TECHNICAL BULLETIN — July 2014

378. Zierer Wave Swinger Service Bulletin

Service Bulletin

| Zierer Bulletin # | Revision: | Page | System | Description: | Date: | Issued: |
|---|-----------|---------------|---------------------|----------------------------|---------------------|------------|
| SB-WS-1001 | 0 | 1 of 4 | Wave Swinger | Service Bullitin | 17.12.2012 | wmt |

3. Actions to be taken:**3.1. Slack Rope Control at Lifting Rope****Slack Rope Control Zierer Article No.: VK080063**

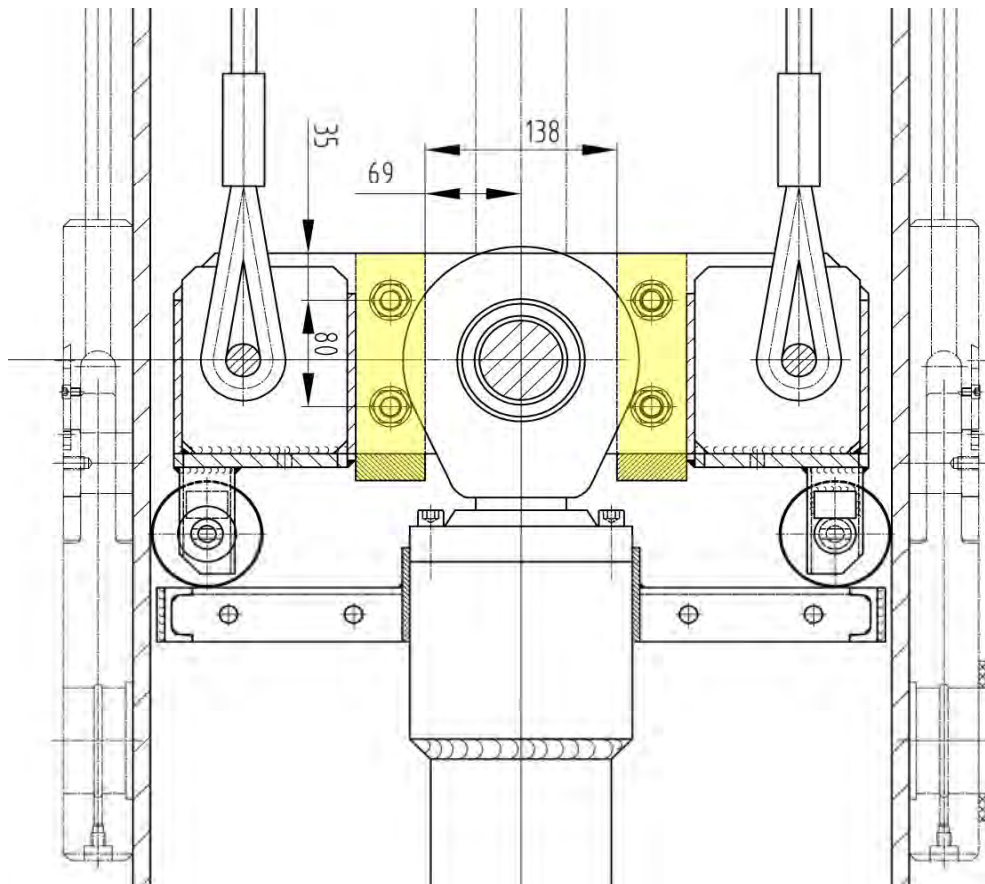
2 sets of slack rope controls, at the lifting rope, monitor and provide for a safe and tightened movement of the lifting rope. The controls are screwed next to the lifting ropes with mounting angles and fixing materials. They need to be subsequently integrated into the electronic control system. In the event of a malfunction, the rope will move away from the range of the sensor and cause a halt to the operation of the facility.

3.2. Hydraulic Cylinder – Safeguarding Guide Cross Top

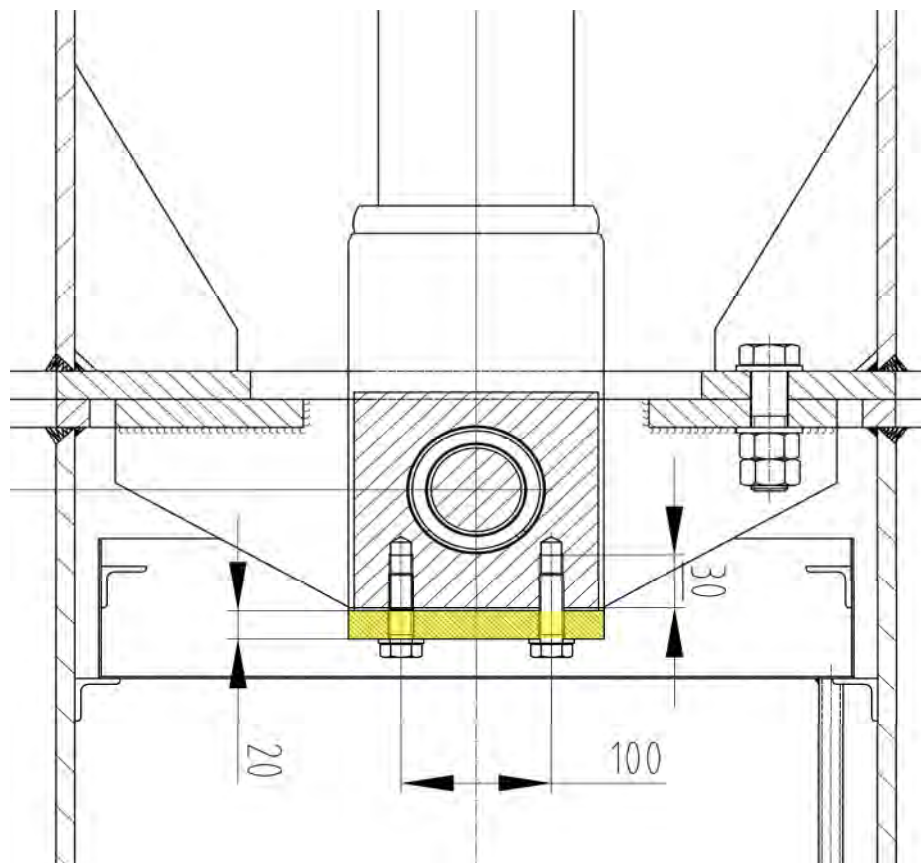
2 items of additional fork-safeguardings prevent the cylinder joint head from slipping away in the event of a breakage of the suspension. The fork-safeguardings are installed axially with a set of 4 screws each, and a distance of 138 mm to one another, at the guide cross.
